FORD 4R100 "UPDATE HANDBOOK"

FORD 4R100 "UPDATE HANDBOOK"

Since the introduction of the 4R100 transmission in model year 1998, there have been many engineering changes to improve Pleaseability, Reliability and Durability concerns. These changes have affected most every part used in this transmission. This "Update Handbook" will explain each change, the reason for the change, and any parts interchangeability concerns created by the change, along with any part numbers needed to update your transmission.

Figure 65

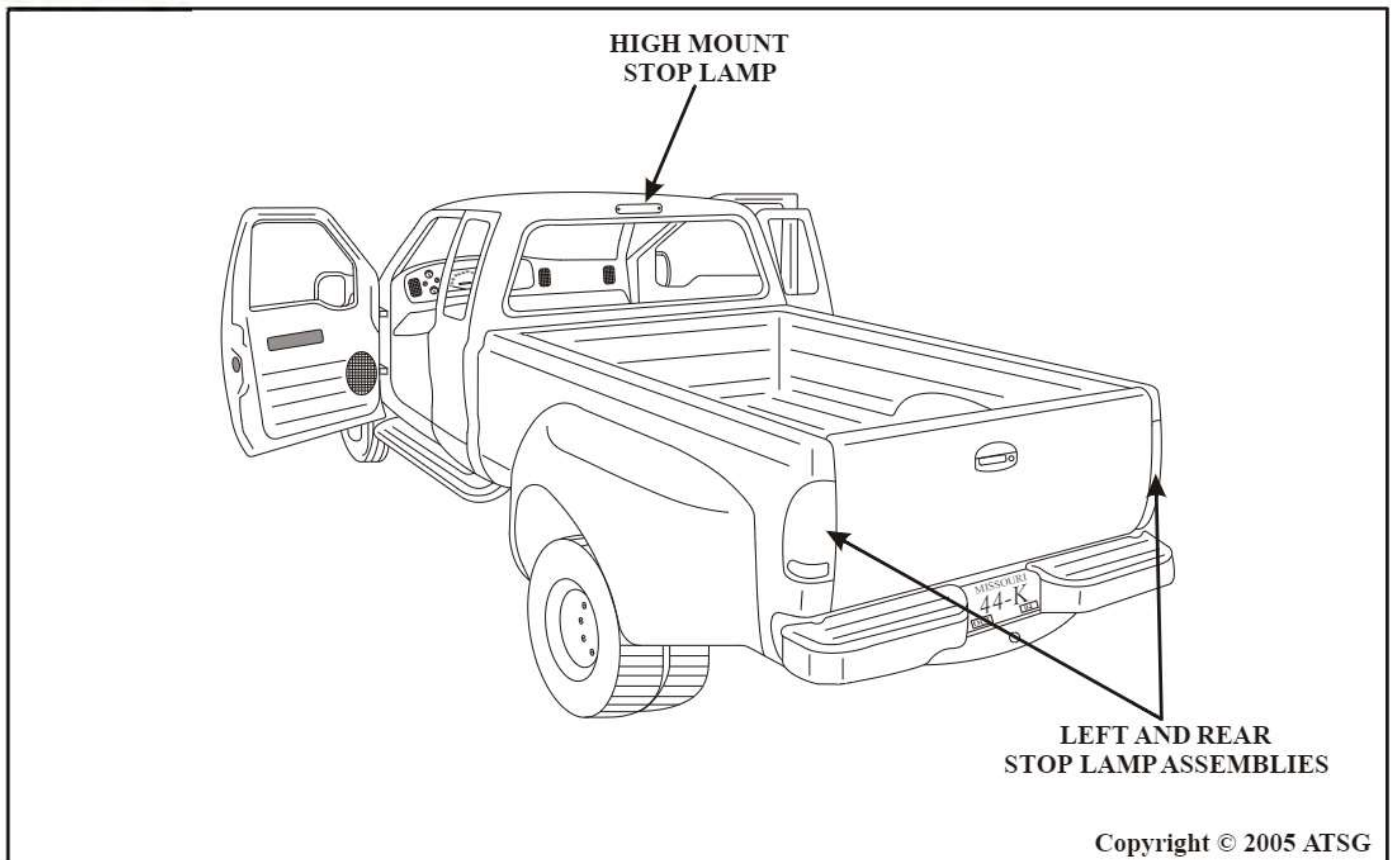
CAUSE NO. 1: One cause for this condition may be that one or more of the vehicle brake light bulbs, including the High Mount brake light may be burned out, or have a damaged filament (See Figure 65). When this condition is present, the PCM will detect an open in the brake lamp circuit, and due to a pull-up resistor in the PCM, will output voltage from PCM terminal 92 to the brake on-off switch (See Figure 66). As a result, the Torque Converter Clutch will not be applied at less than 30 percent throttle.

Replace any burned out brake lamp bulbs, including the High Mount brake lamp bulb, as shown in Figure 65. It is also important to note, that a bad ground for the rear lamp assembly, has also been known to cause the identical symptom. Refer to Figure 69 for the rear lamp assemblies ground location.

Figure 71

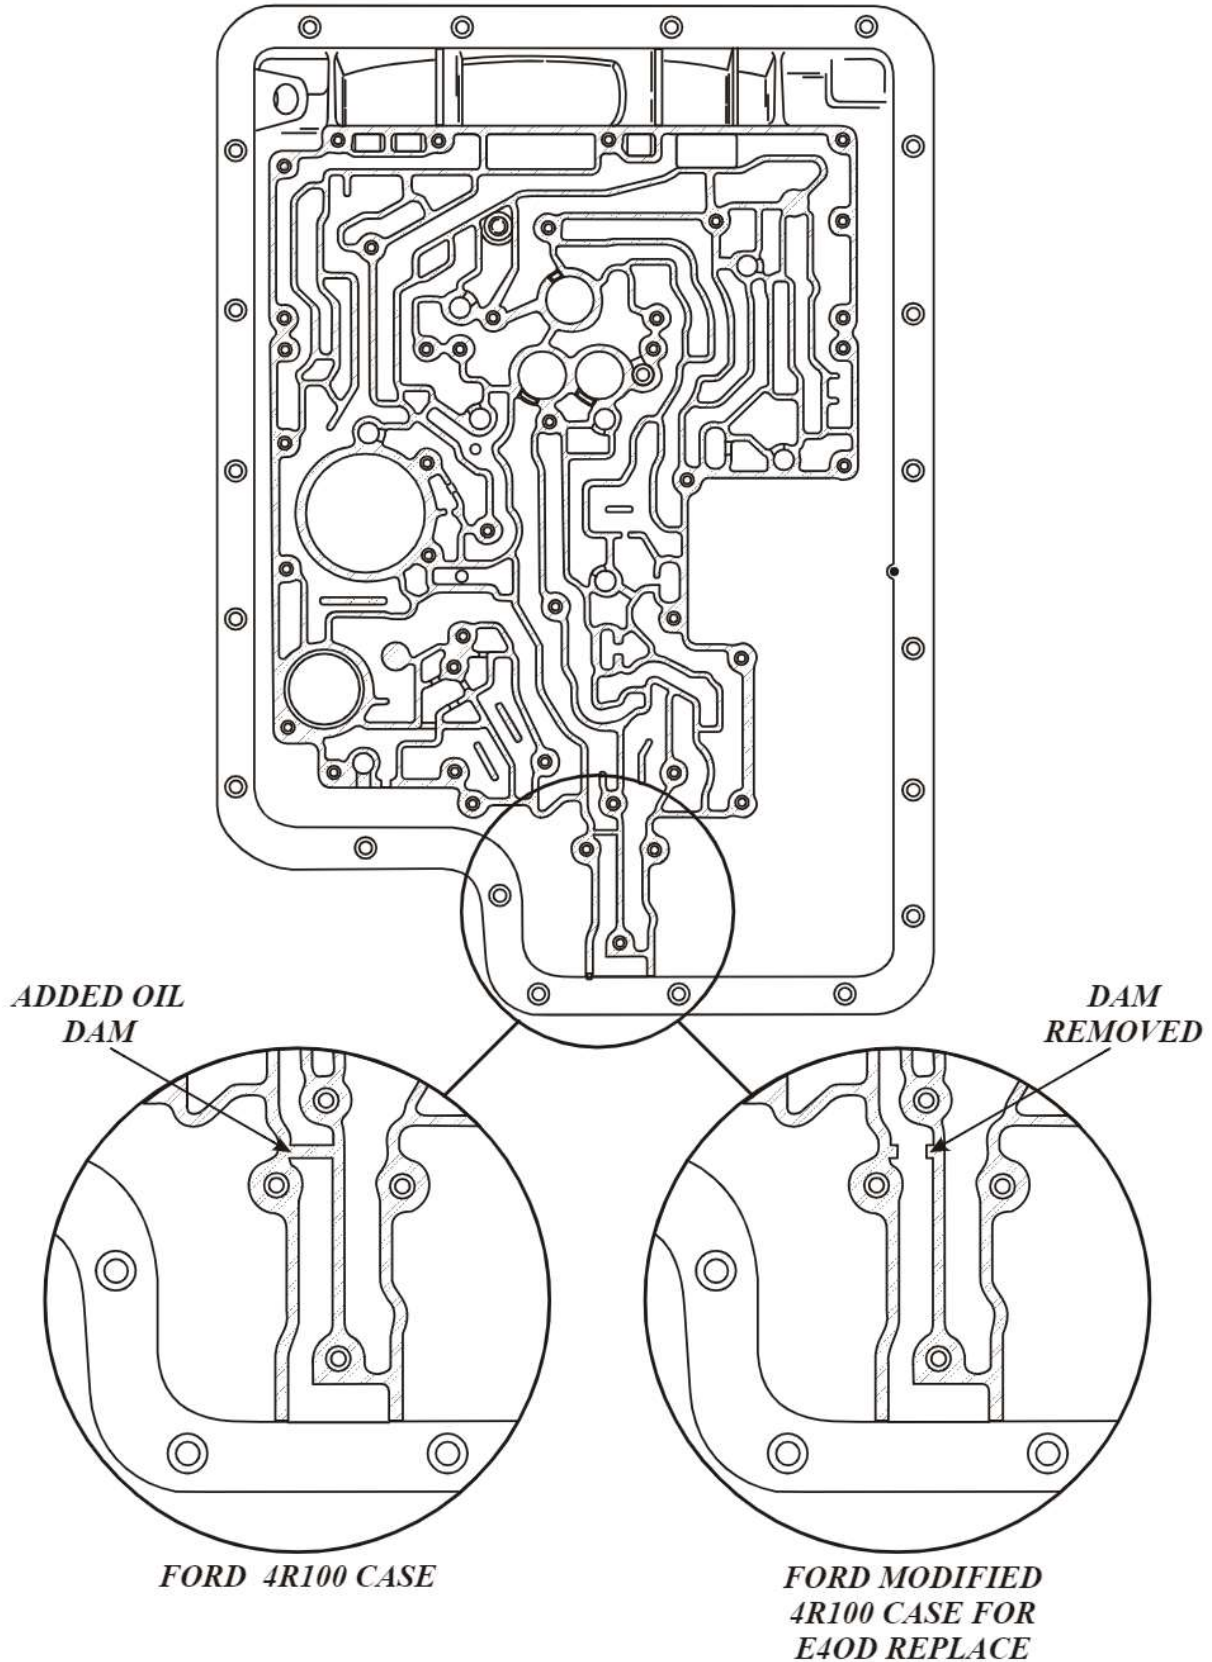
CHANGE: Currently, the *"only"* new case available from Ford Motor Company, for replacement in any E4OD equipped vehicles, is a modified 4R100 case. Ford has machined out the dam in the case that separates center and rear lube, near the rear of the case, as shown in Figure 71.

Figure 72

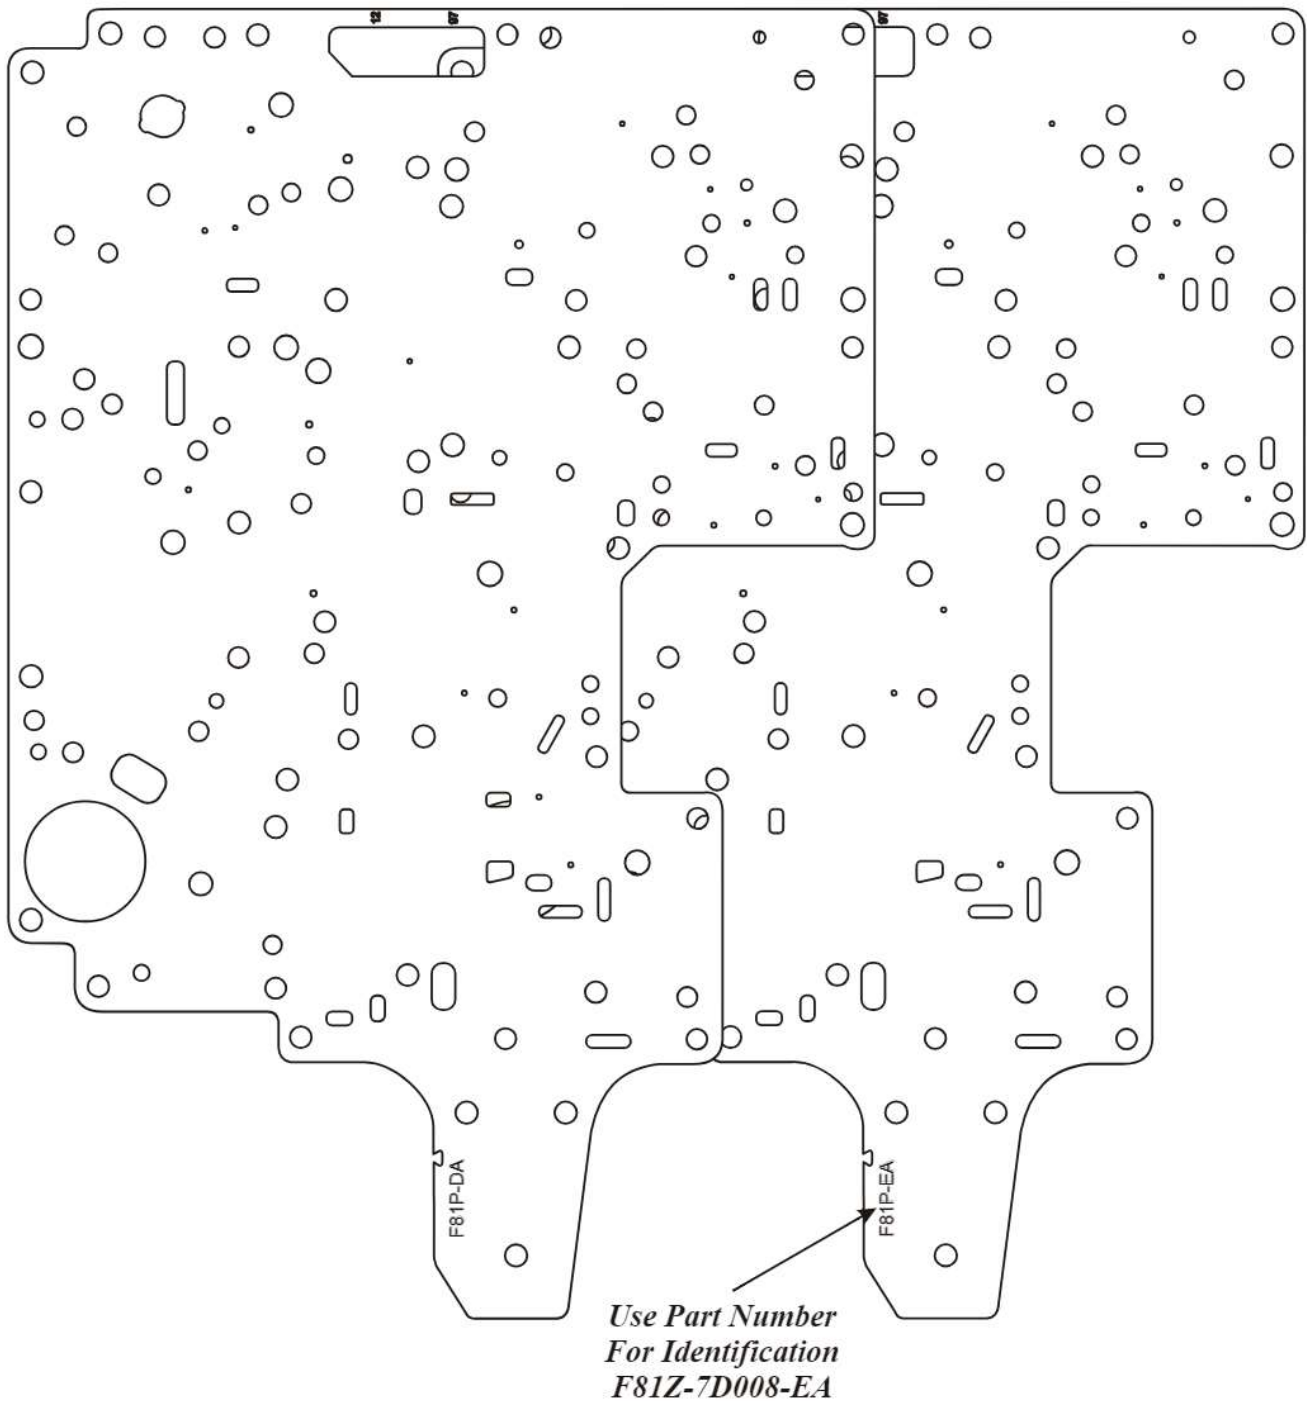
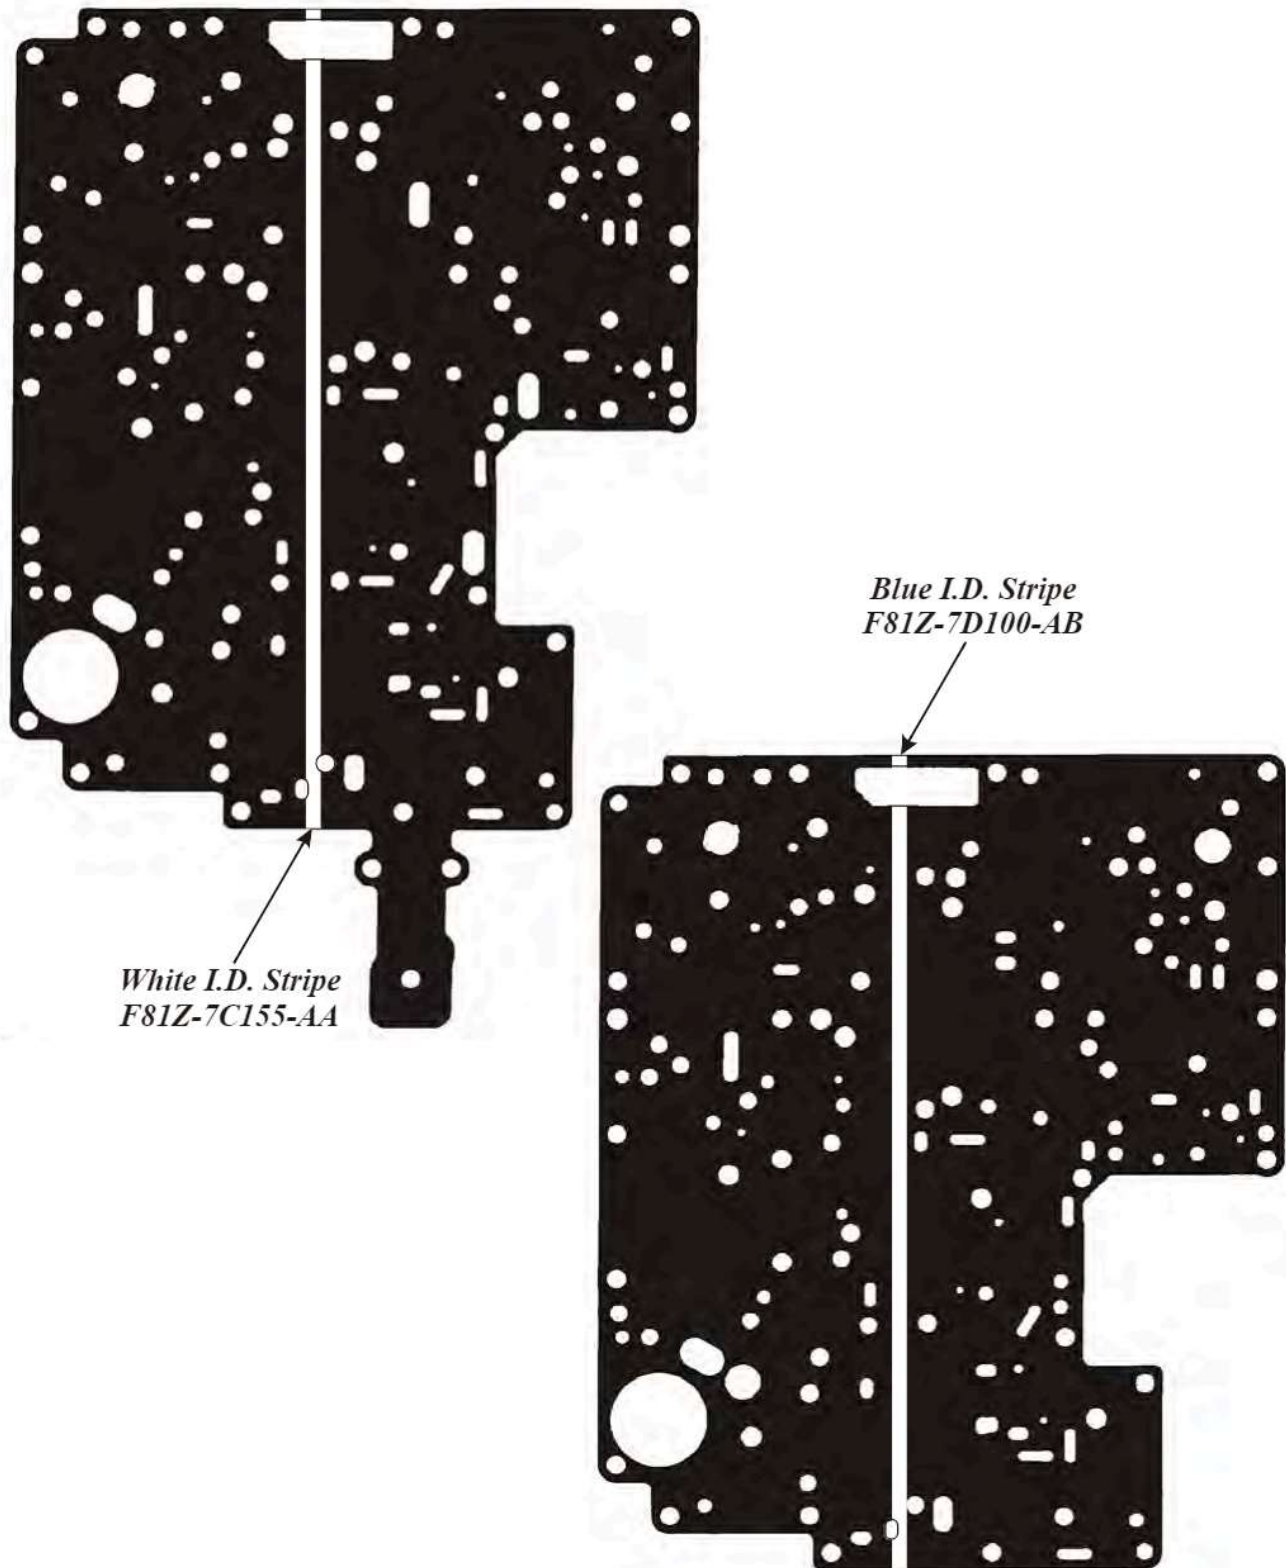
- (1) SPACER PLATE - Ford Motor Co. part number F81Z-7A008-EA or F8UZ-7A008-CA, as shown in Figure 72.
- (2) CASE TO SPACER PLATE GASKET - Ford Motor Co. part number F81Z-7C155-AA, with "White" stripe for identification, as shown in Figure 73.

Figure 74

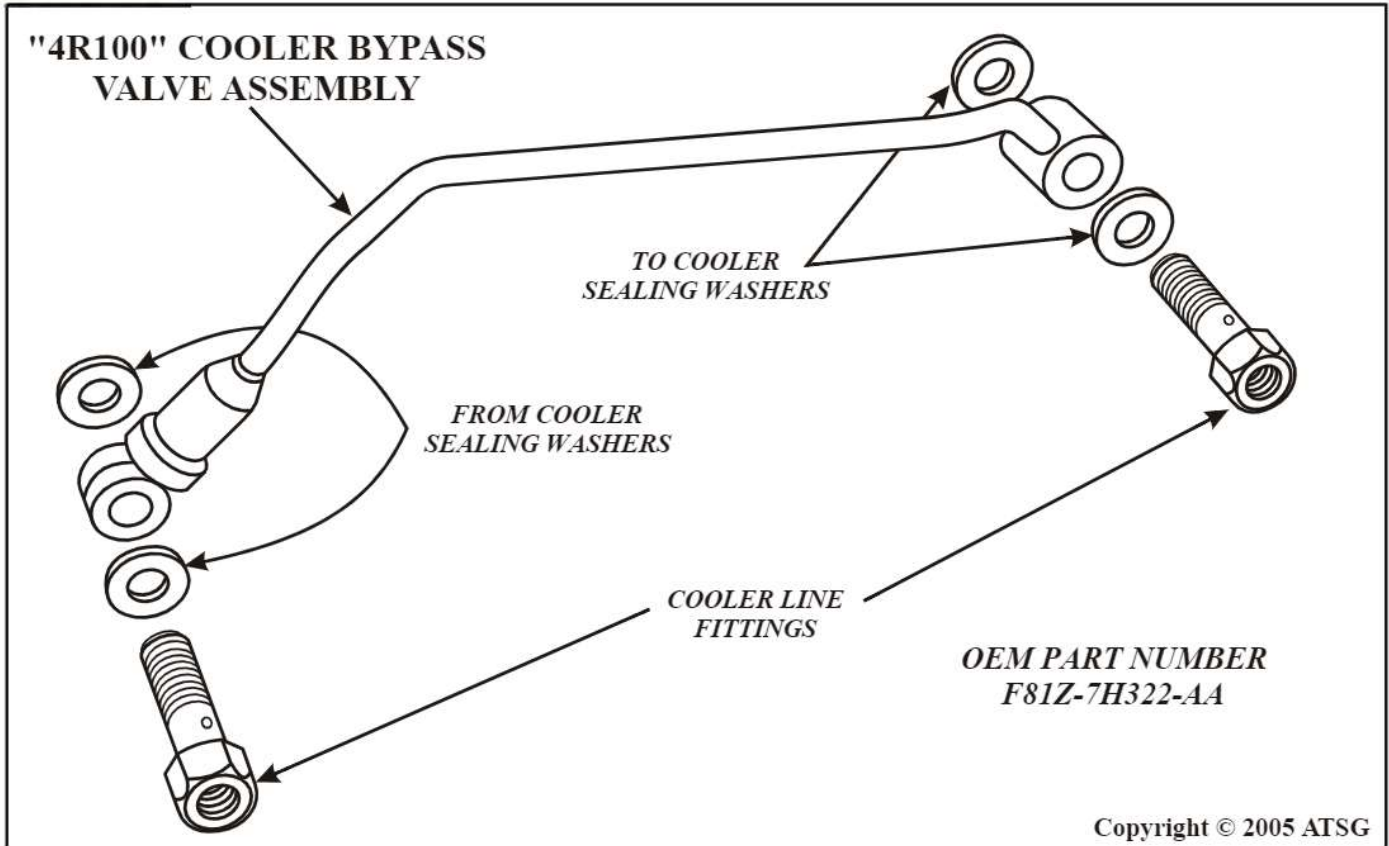
- (3) SPACER PLATE TO V.B. GASKET - Ford Motor Co. part number F81Z-7D100-AB, with "Blue" stripe for identification, as shown in Figure 73.
- (4) COOLER BYPASS ASSEMBLY - Ford Motor Co. part number F81Z-7H322-AA for 1996 models only, as shown in Figure 74. 1997 and 1998 models came with cooler bypass.

Figure 75

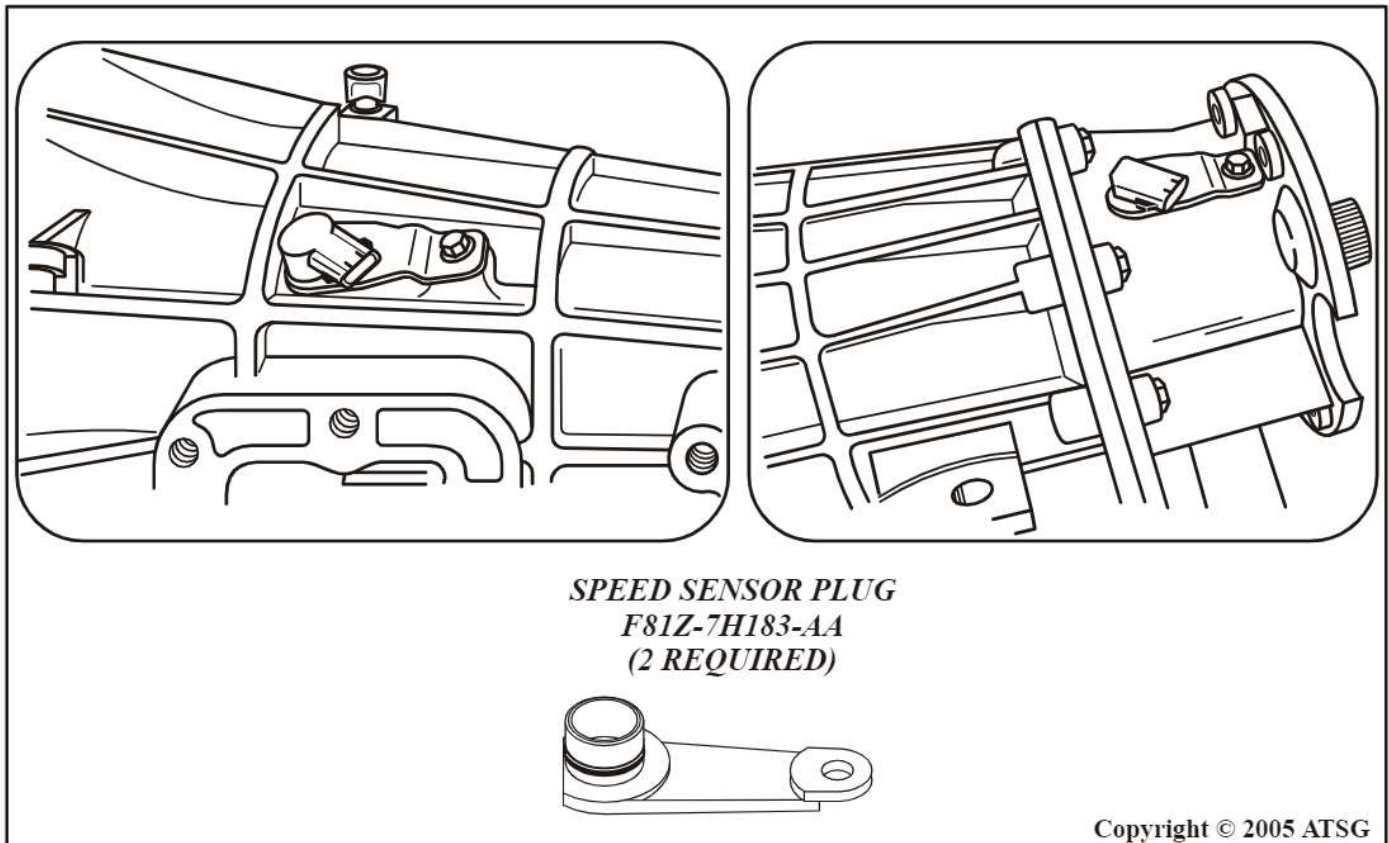
- (5) SPEED SENSOR PLUG - Ford Motor Co. part number F81Z-7H183-AA, and 2 are required, as shown in Figure 75.
- (6) LUBE ORIFICE PLUG - Ford Motor Co. part number F81Z-7E380-AA, which should come with the new case from Ford, as shown in Figure 76.
